MOON LAKE POWER PLANT PROJECT Units 1 and 2

ENVIRONMENTAL IMPACT STATEMENT

FINAL

**MOON LAKE POWER PLANT PROJECT
UNITS 1 AND 2**

FIGURE 3-3

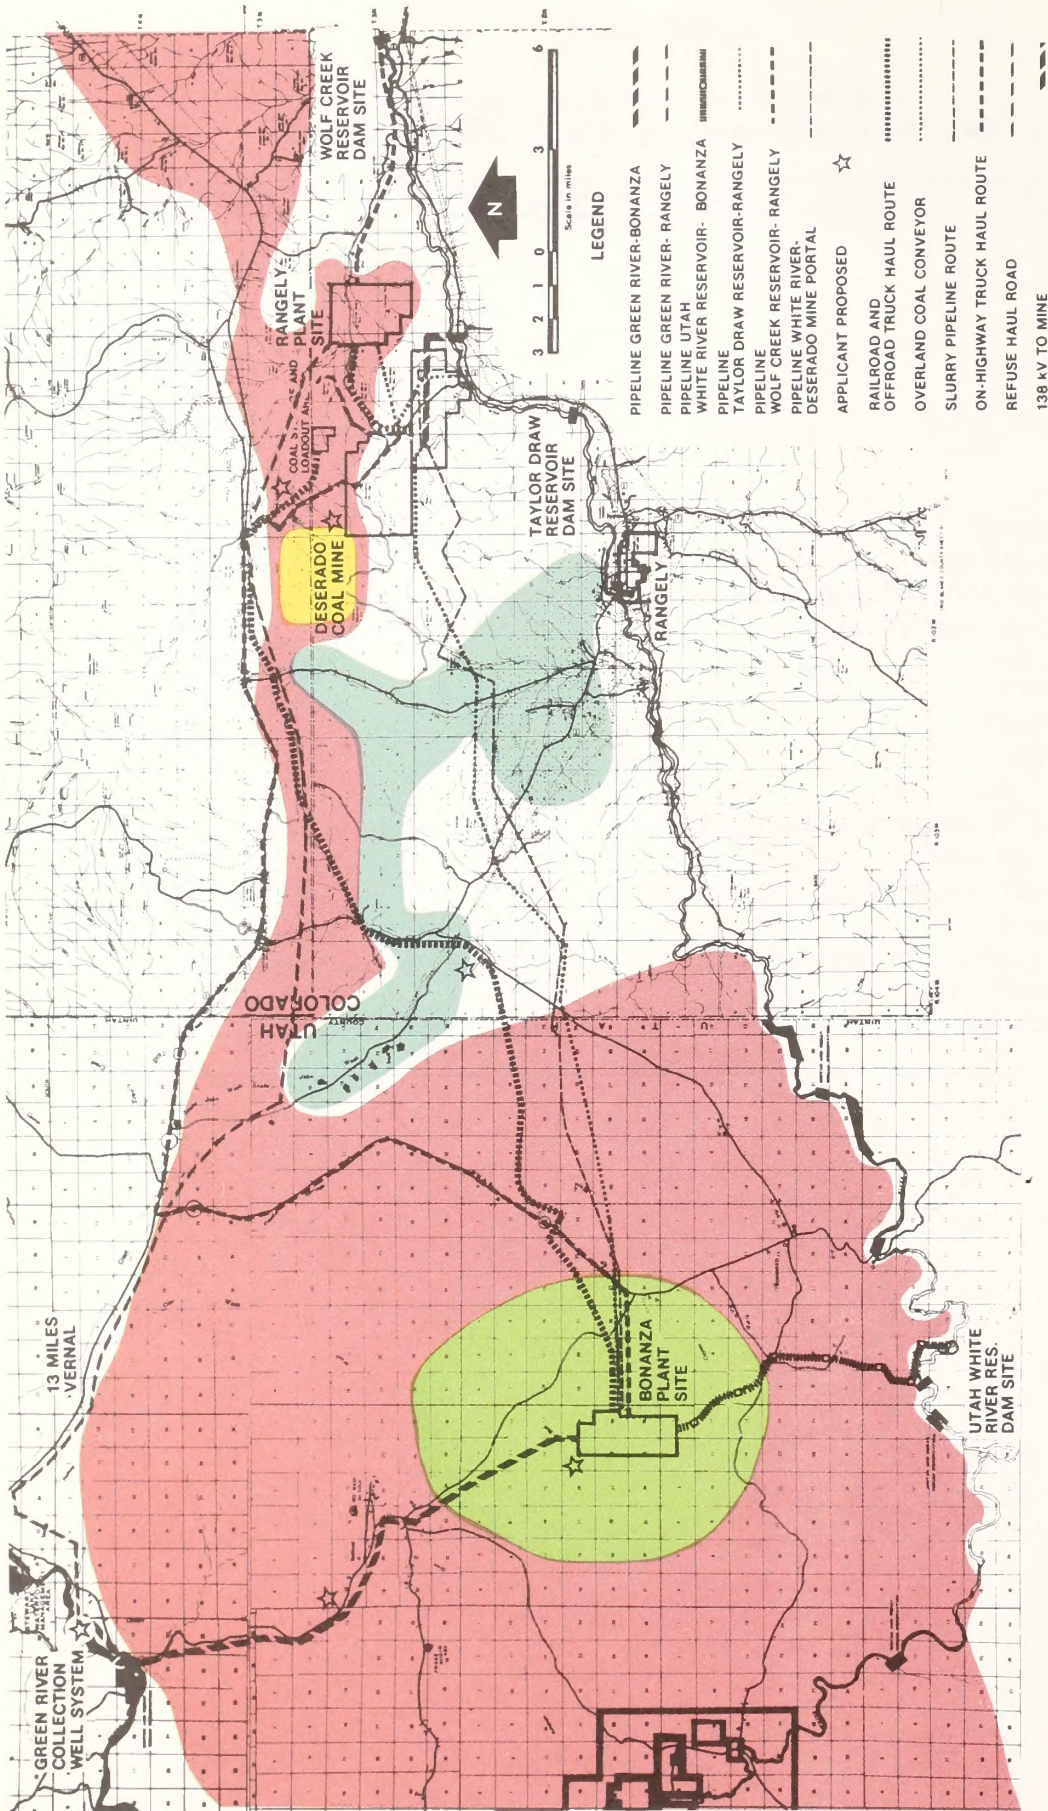
15.5 P. 177; Figure 3-3 The legend and map delineations on this figure are difficult to interpret. We suggest more contrasting colors be used to delineate fawning areas and winter range.

Thank you for your comment. Figure 3-3 is reprinted in this Final EIS.
